ORDINARY MEETING	18
22 MAY 2024

PRELIMINARY APPROVAL FOR RECONFIGURING A LOT (2 LOTS INTO 706 RESIDENTIAL LOTS) – MT PETER ROAD & 505R MT PETER ROAD, MOUNT PETER – DIVISION 1

PROPOSAL: PRELIMINARY APPROVAL FOR RECONFIGURING A LOT (2 LOTS INTO 706 LOTS)

RECOMMENDATION

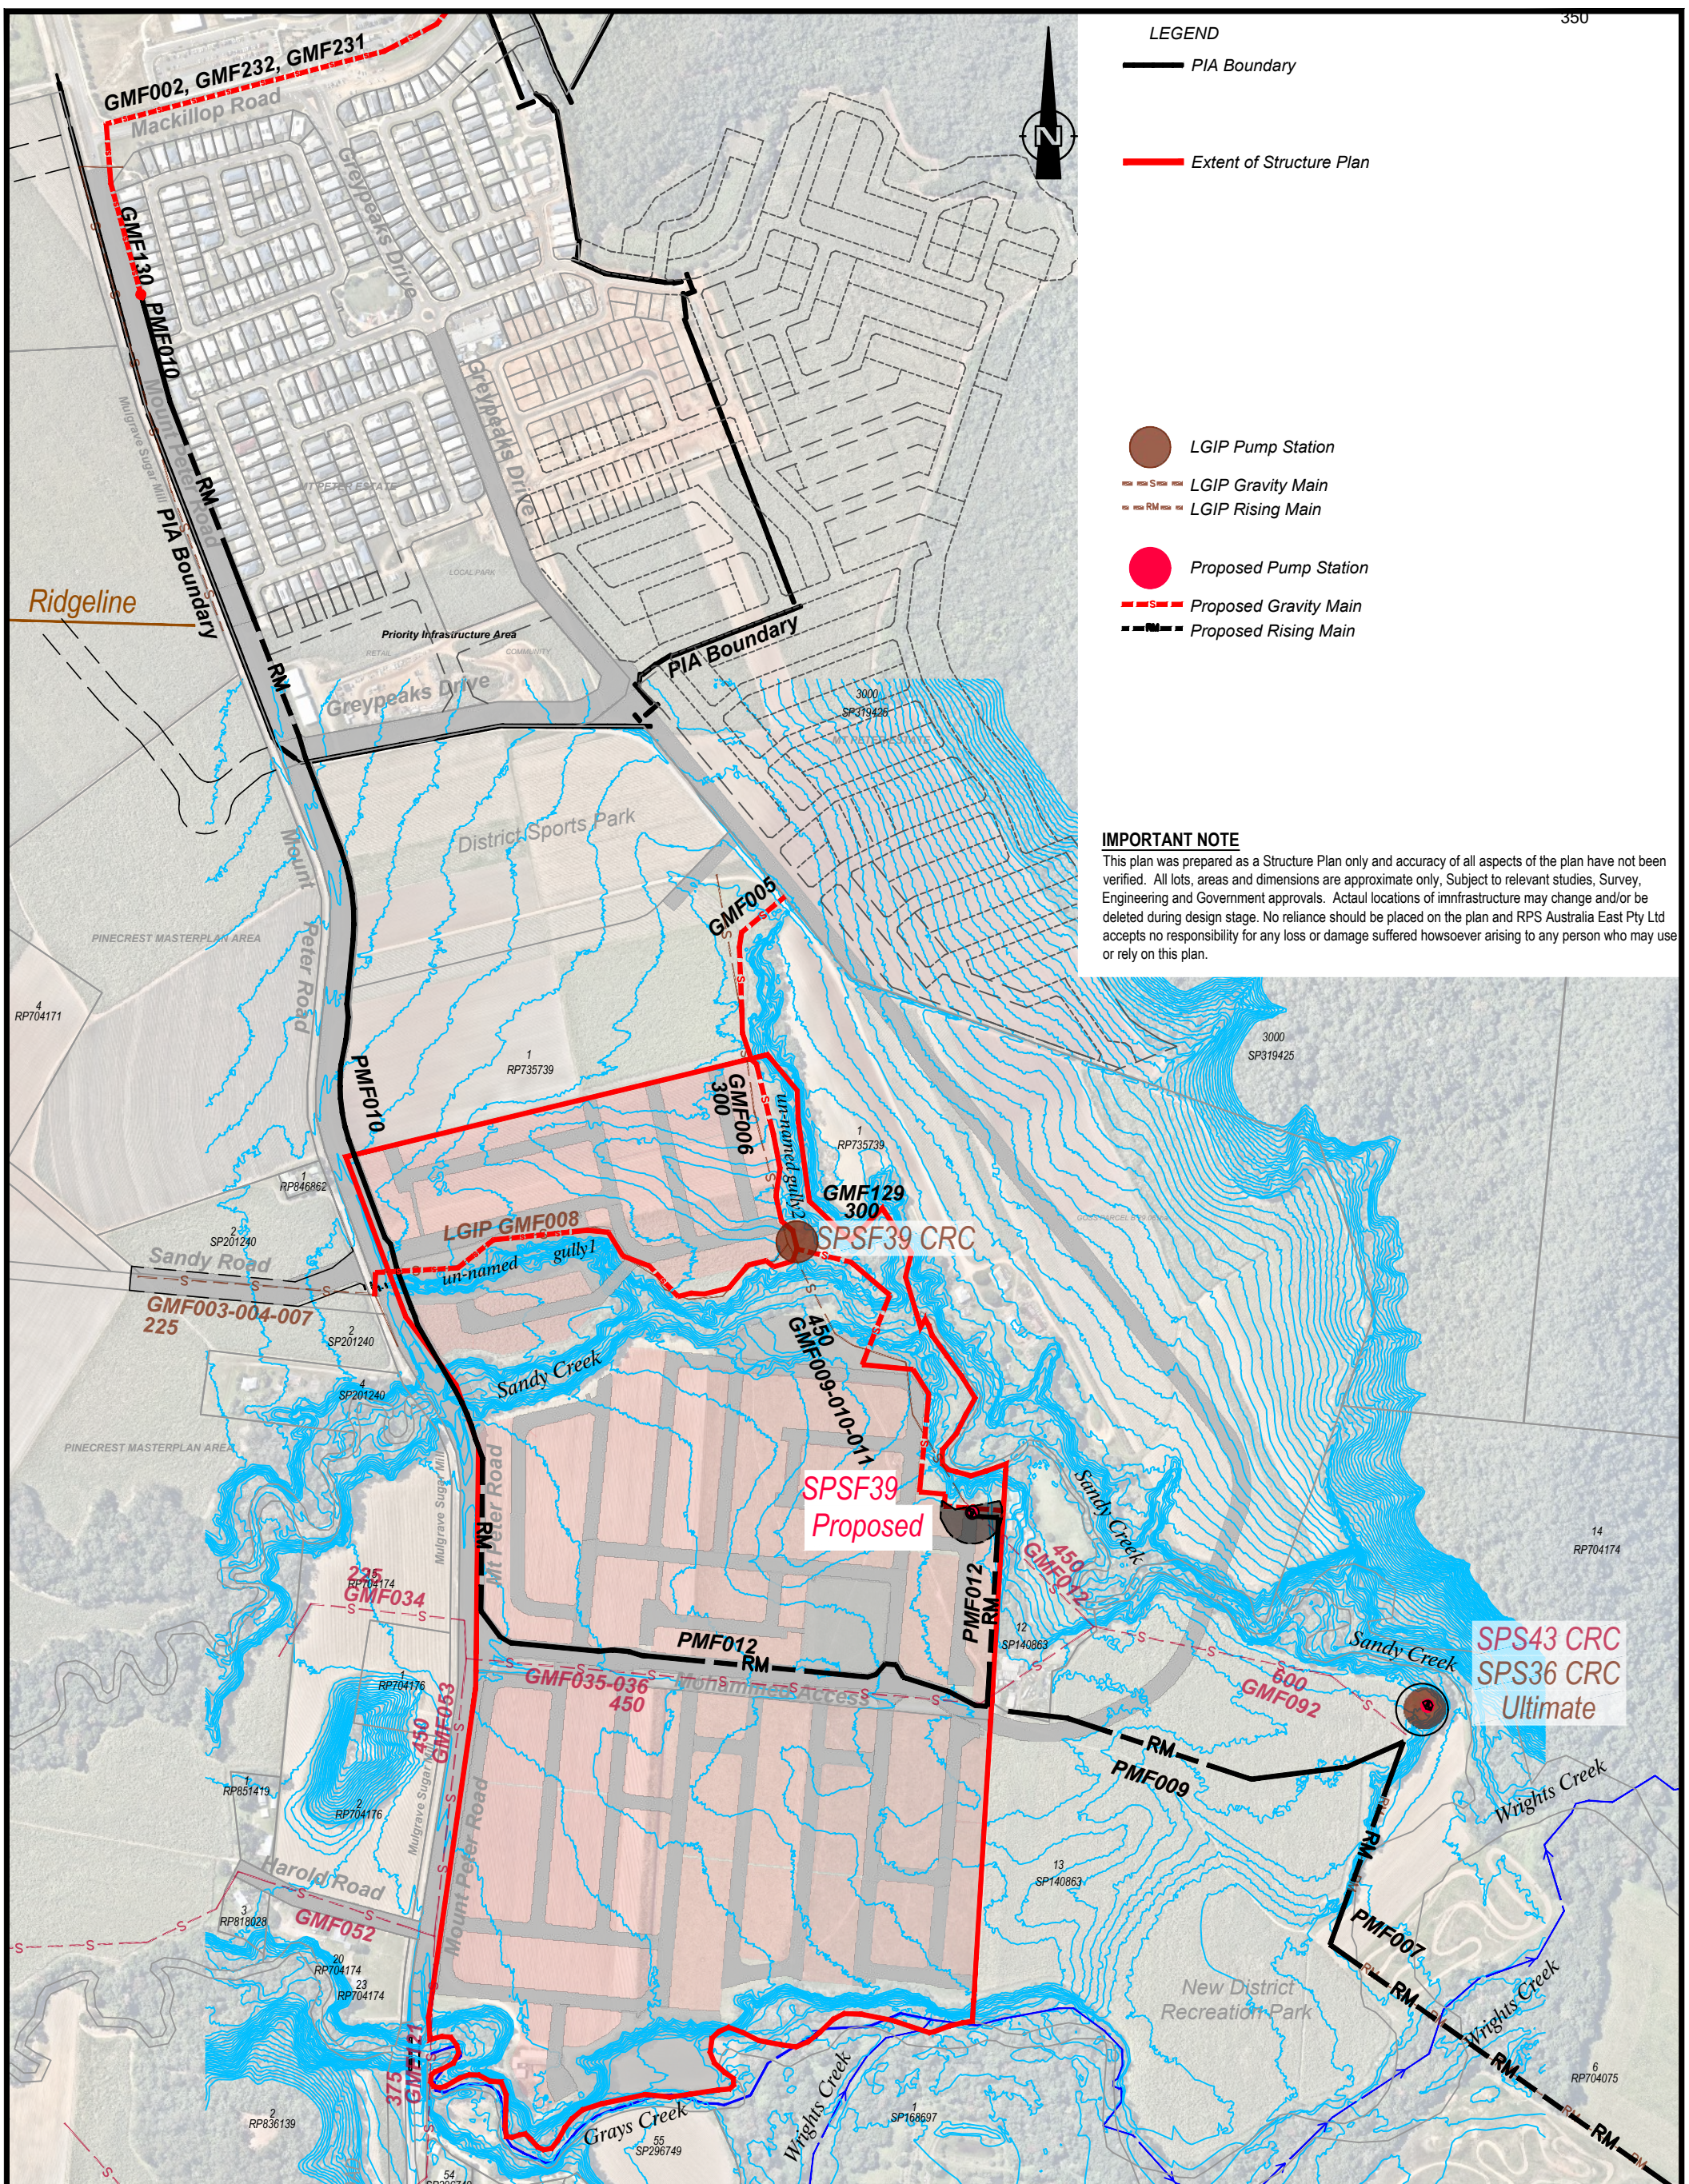
- 4. **It has not been demonstrated that the proposed trunk sewer and water trunk infrastructure would be compatible with the trunk infrastructure planned to be delivered under the LGIP because:**

- b. **the proposed relocation of sewer pump SPSF39, planned in the LGIP to be delivered in 2031, is not appropriate;**
 - c. **it has not been demonstrated that the proposed trunk water infrastructure will provide an adequate level of service in terms of adequate pressure and network security of supply.**
